# UNITED STATES PATENT AND TRADEMARK OFFICE

APPLICATION NO.	FILING DATE	FIRST NAMED INVENTOR	ATTORNEY DOCKET NO.	CONFIRMATION NO.
10/500,053	06/24/2004	Mordechai Forkosh	055/04085	9159

# Office Action Summary

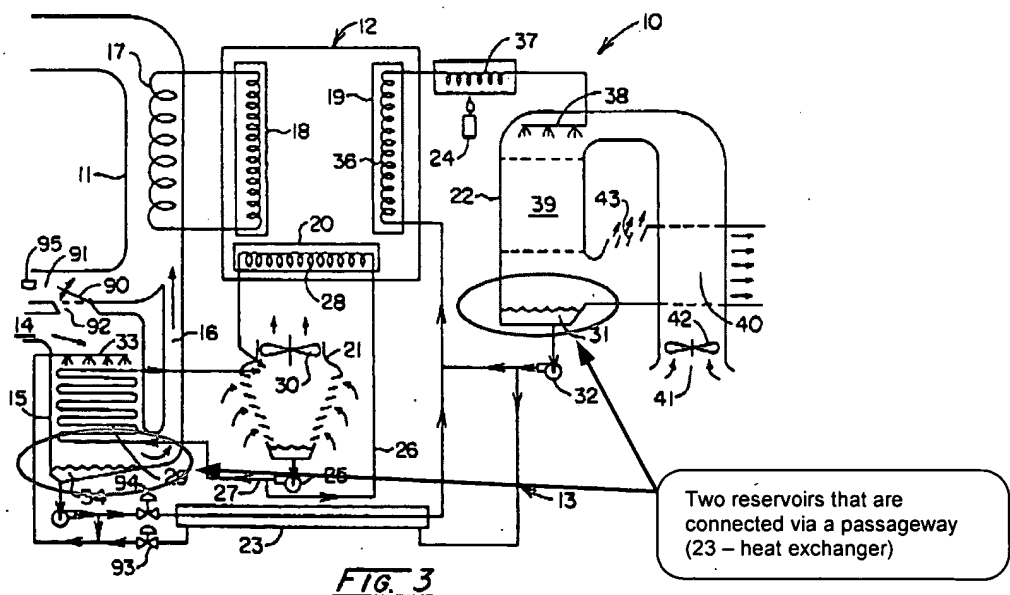
Regarding claim 1, Wilkinson discloses a dehumidifier (apparatus) that produces dehumidified air and utilizes a liquid desiccant for drying (as seen in Figure 3), the

dehumidifier comprising a liquid desiccant (72, 74, 78 – desiccant solution; Figures 3, 5, 10) in two reservoirs (as seen in the illustration of Figure 3 below), one of which contains a higher desiccant concentration than the other (see col. 5, line 60 – col. 6, line 13); a dehumidifier unit (13 – liquid desiccant dehumidification subsystem) into which moist air is introduced and from which less moist air is removed after dehumidification by liquid desiccant transferred thereto (see col. 4, lines 49-60; Figure 3); a regenerator unit (12 – absorption chiller refrigeration subsystem) which receives desiccant solution that has absorbed from the moist air and removes moisture from it (see col. 4, line 61 – col. 5, line 11; Figure 4); and a passageway (23 – heat exchanger) connecting the reservoirs (as seen in the illustration of Figure 3 below), a cooling tower (21 – cooling tower) that provides at least one non-desiccant fluid (water) at a temperature lower than the temperature of the liquid desiccant in one of the reservoirs (see col. 5, lines 39-50; Figure 3); and at least one heat exchanger (29 – cooling coils) situated in the one reservoir via which the liquid desiccant in the one reservoir is cooled by the at least one fluid (see col. 5, lines 39-50; Figure 3).
